Reference: NHTSA Identification Number 12V-197

## **Safety Recall M10 / NHTSA 12V-197 ABS/ESC Wiring**

**2011 – 2012 (LD) Dodge Charger**

**(LX) Chrysler 300**

Figure 1 – PDC Cartridge Fuse Location

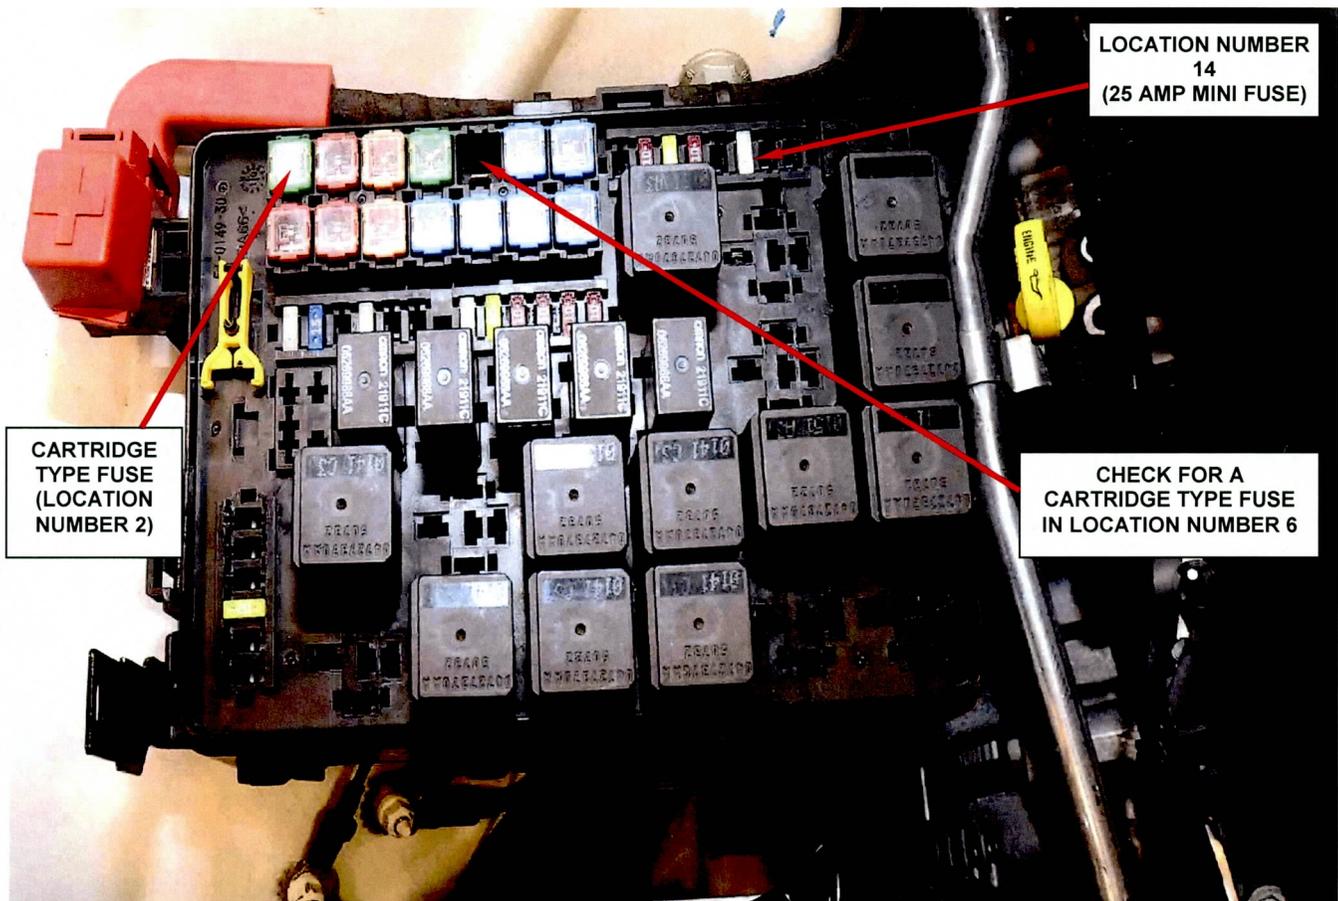
1. Remove the Power Distribution Center (PDC) cover.
2. Check for the presence of a 25 amp cartridge fuse (Figure 1) in PDC location number 6:
  - If PDC location number 6 **has** a 25 amp cartridge fuse, a **fuse upgrade is not required**. No further action is required. Install the PDC cover, close the hood and return the vehicle to the customer.
  - If PDC location number 6 **does not have** a 25 amp cartridge fuse, a **fuse upgrade is required**. Continue with Step 3 of this procedure.

**Figure 2 – PDC Retaining Tabs**

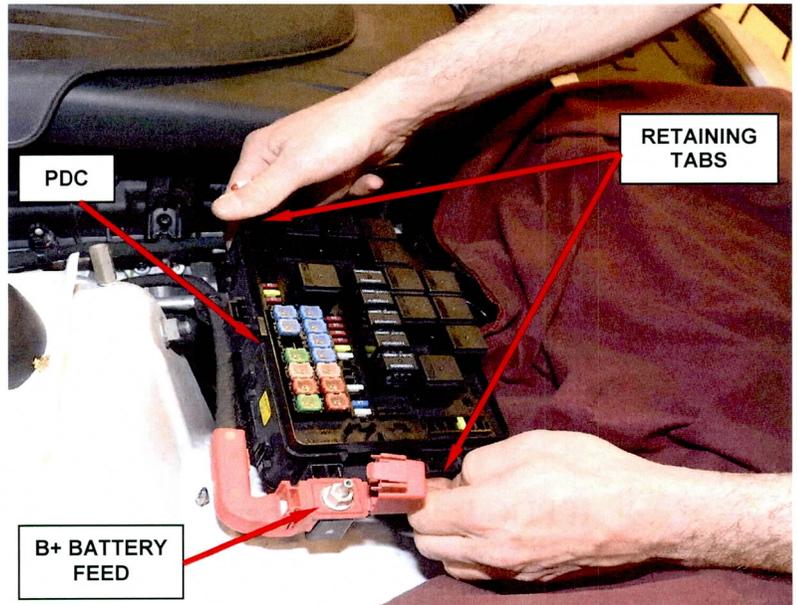
3. Disengage the retaining tabs that secures the PDC to the mounting bracket (Figure 2).
4. Disconnect the main B+ battery feed wire on the PDC (Figure 2).
5. Remove and save the PDC mounting bracket.
6. Turn the PDC over to expose the bottom side of the PDC.
7. Carefully open the PDC bottom cover (Figure 3).

**Figure 3 – Terminal Black Plastic Lock**

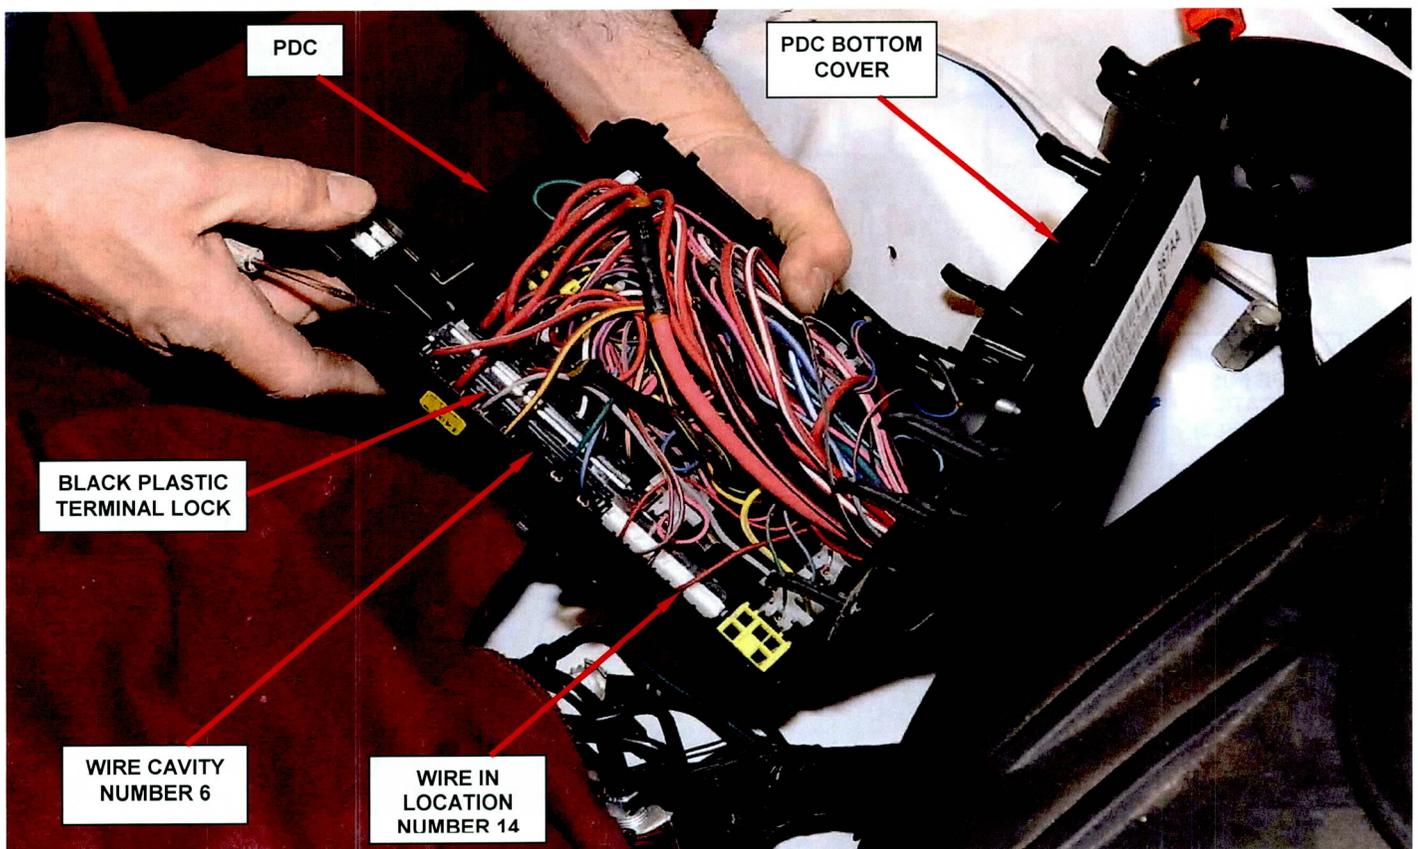
8. Using a small pick tool, remove and discard the black plastic terminal lock (Figure 3).

**Figure 4 – Cavity Number 6**

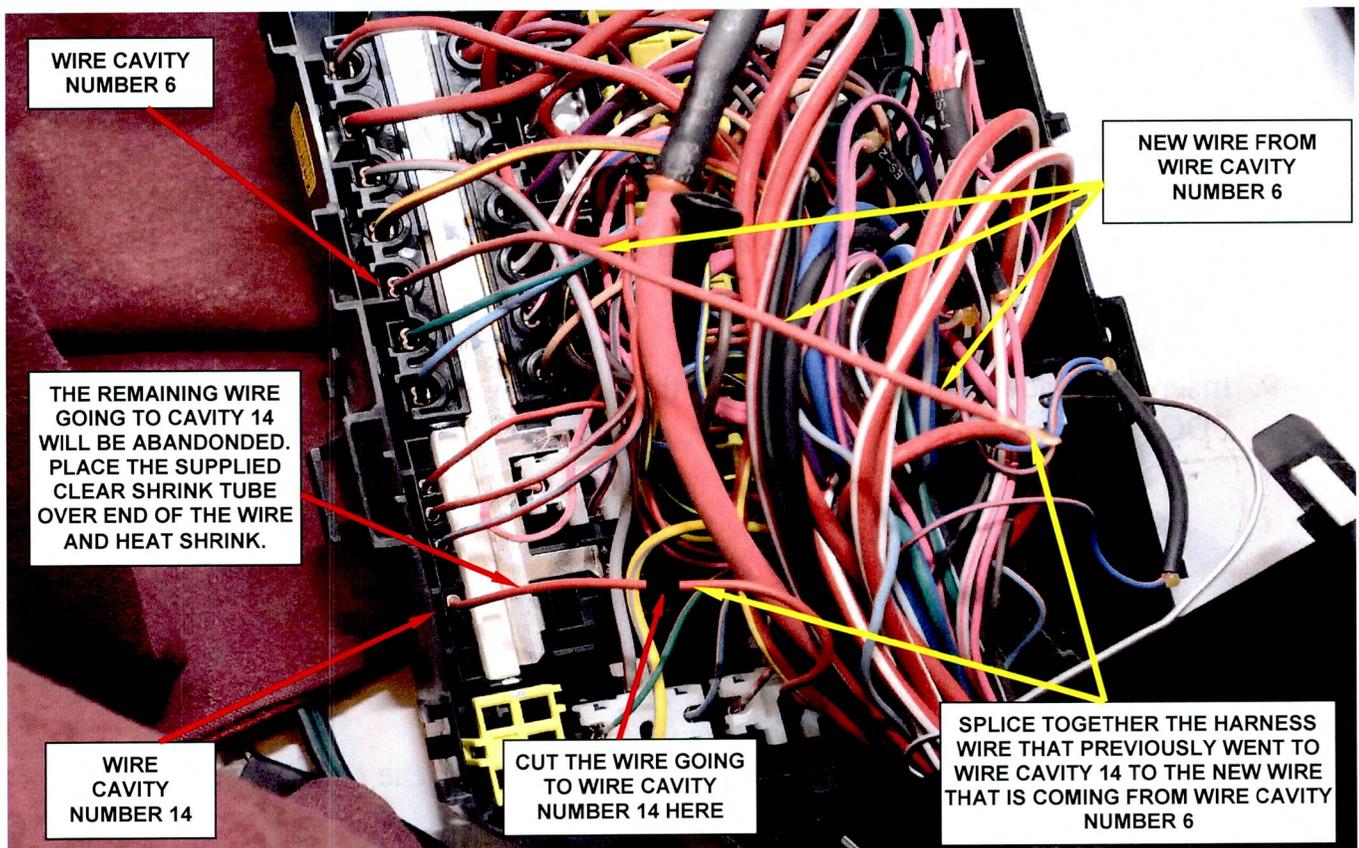
9. Insert the blade terminal provided in the repair kit into cavity number 6 of the PDC (Figure 4).

10. Install the new black plastic terminal lock provided in the repair kit (Figure 4).

**Figure 6 – Install Splice Band Clamp**

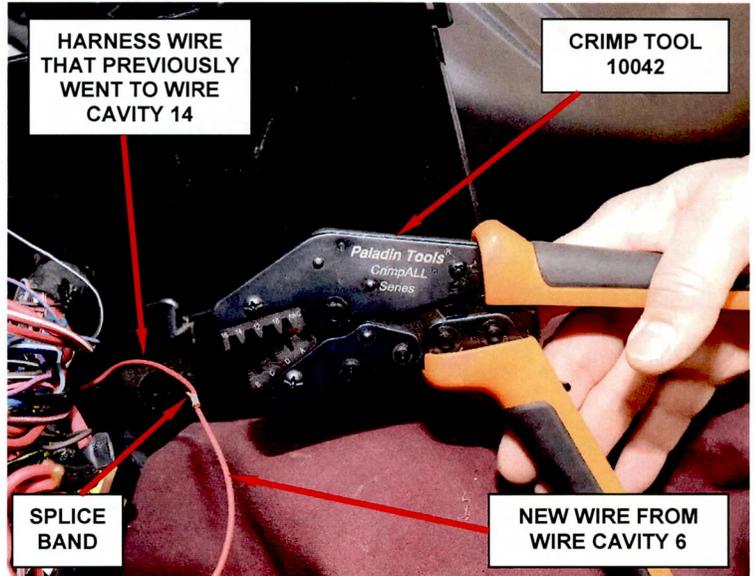
16. Using the supplied splice band clamp and crimp tool 10042, crimp the wire that had the insulation stripped in Step 14 to the wire that was added in Step 9 (Figure 6).

**Figure 7 – Solder Wire**

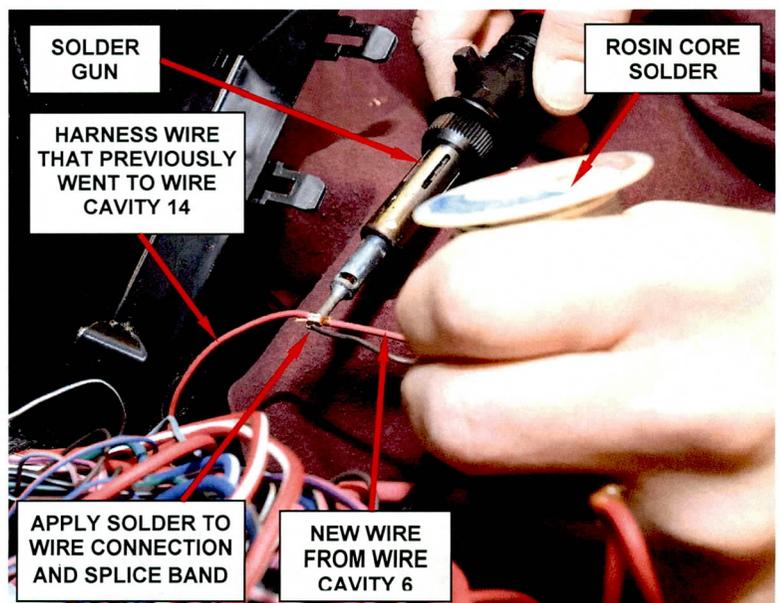
17. Solder the crimp installed in Step 16 with rosin core solder (Figure 7).

Figure 8 – Fuse Removal and Installation

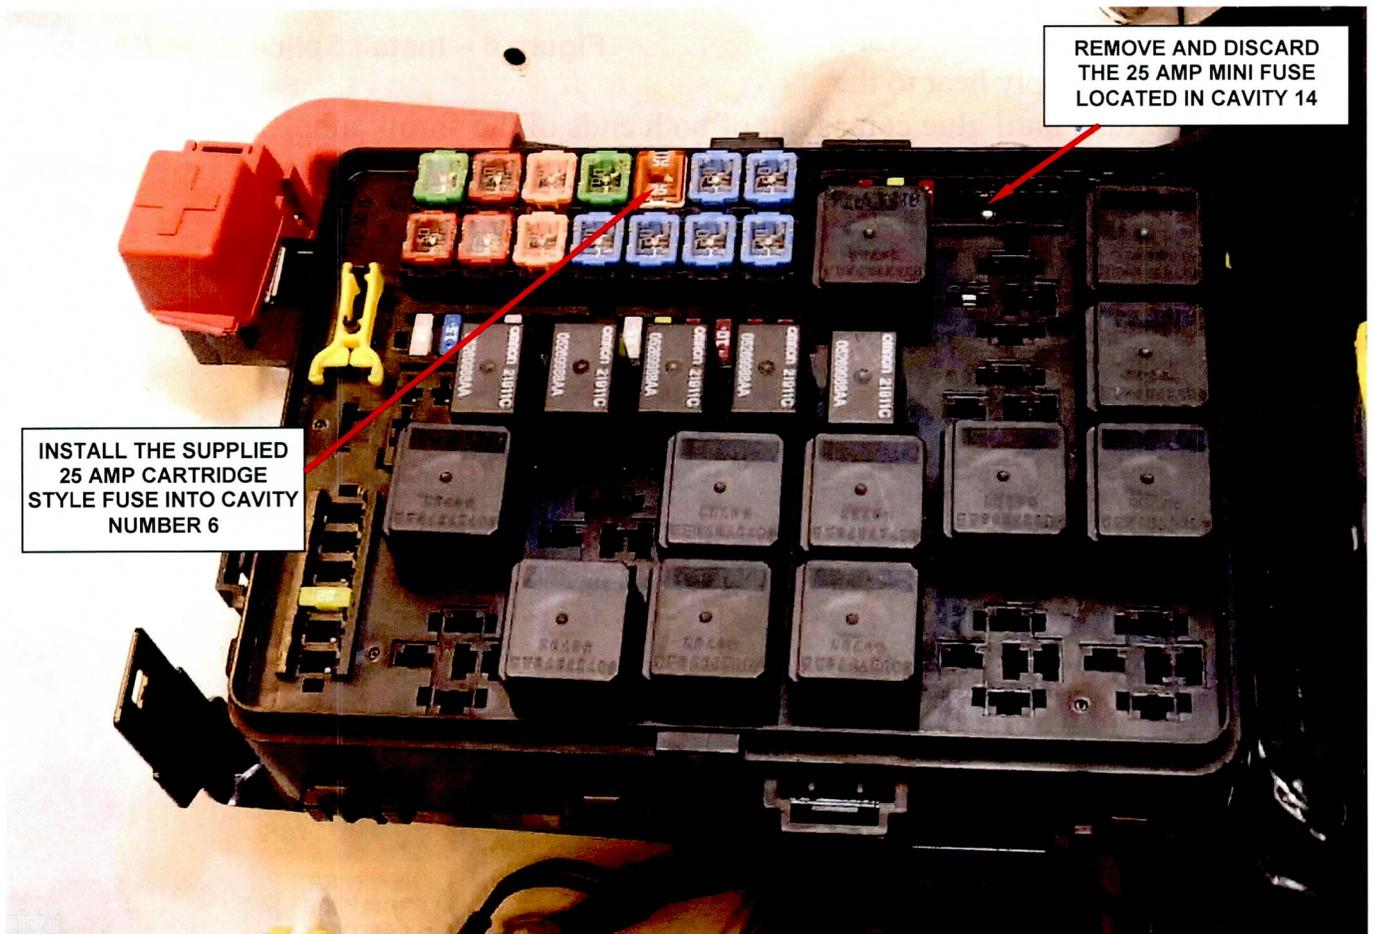
23. Remove and discard the white 25 amp mini fuse located in cavity number 14 of the PDC (Figure 8).

24. Install the new fuse supplied in the repair kit into cavity number 6 of the PDC (Figure 8).

**Figure 9 – Install Circuit Location Labels**

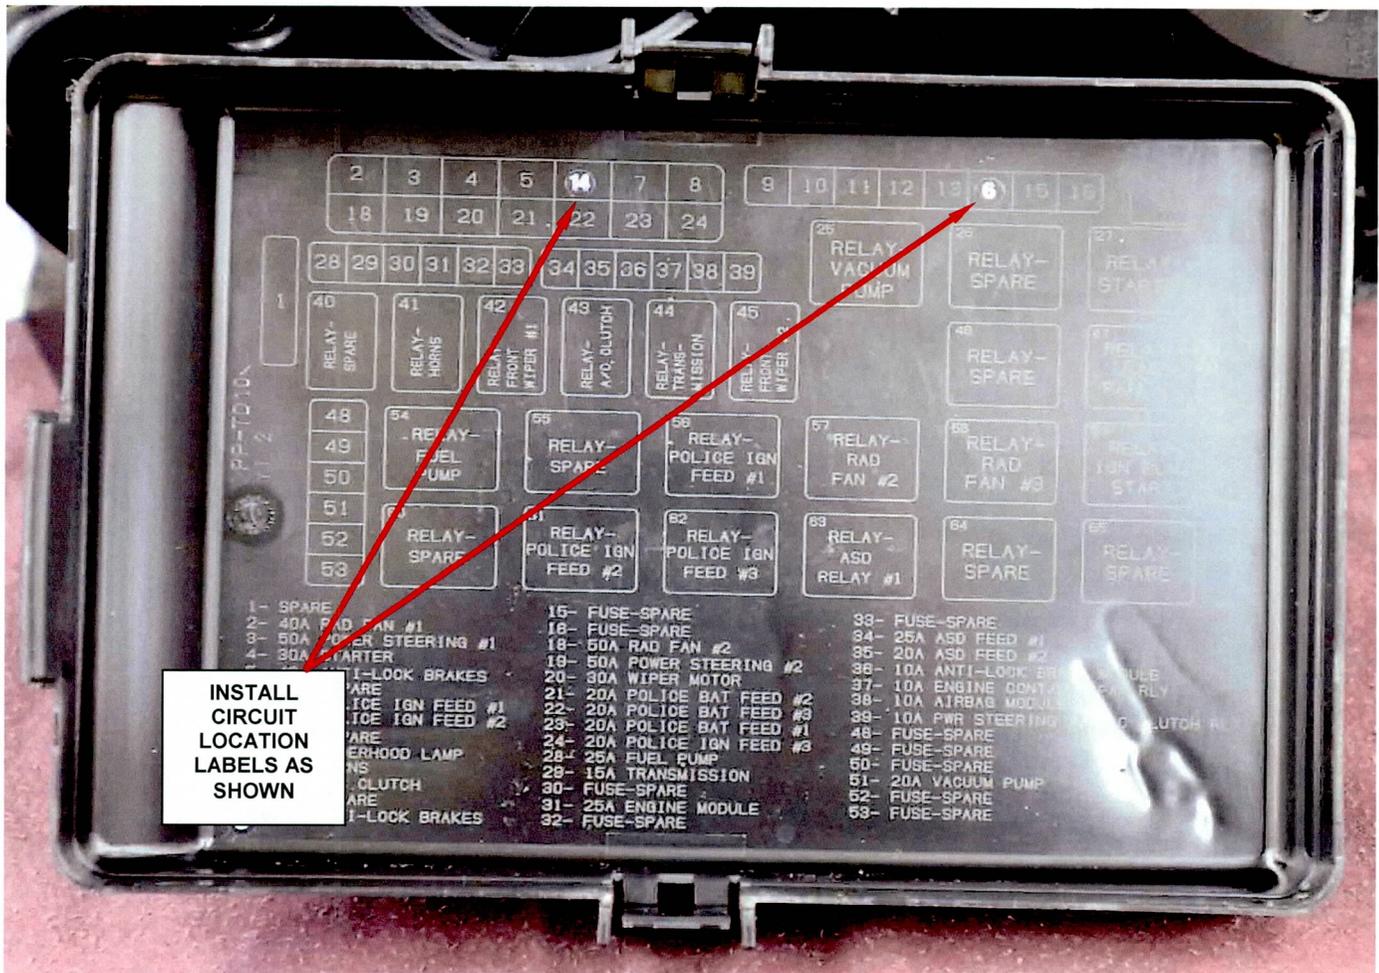
25. Install the new fuse location stickers supplied in the repair kit onto the fuse location diagram on the inside of PDC cover (Figure 9).
26. Install the PDC cover onto the PDC.
27. Connect the negative battery cable to the battery.
28. Connect the wiTECH scan tool and clear all Diagnostic Trouble Codes (DTC's).
29. Start the vehicle and verify that the ABS light, brake light and ESP light in the instrument cluster turn off after the initial "bulb check."
30. Remove the wiTECH VCI pod from the vehicle and return the vehicle to the customer.
